# Access Compliance Report Public Rights-of-Way (Curb Ramps)

Main Street: ROSSMOOR\_CENTER\_WAY Cross Street: N/A Location: SE

ADA ID: RPRK211208114951 Ramp Type: Type 1 - Perpendicular Diagonal Initial Pass/Fail: Pass Overall Compliance: No Severity Score: 14

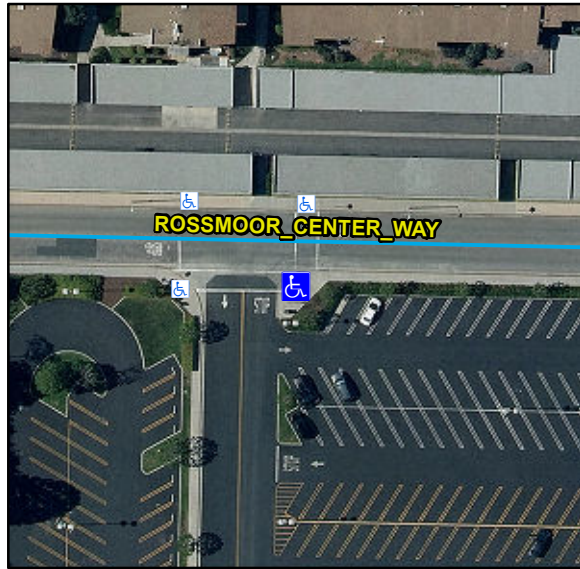
| Compliance | Description                           | Data | Compliance | Description                   | Data   |
|------------|---------------------------------------|------|------------|-------------------------------|--------|
| Yes        | Landing Cross Slope (%)               | 0.5  | No         | DWS Provided                  | No     |
| No         | Gutter Lip Height (in)                | 0.25 |            | Road Run Slope (%)            | 2.9    |
| No         | Gutter Cross Slope (%)                | 3.2  |            |                               |        |

Remove & Replace Curb Ramp With Two New Directional Ramps or Equivalent. Remove & Replace Gutter.

R304.2.1, R305, R302.7.2, R304.5.3, STD 1115
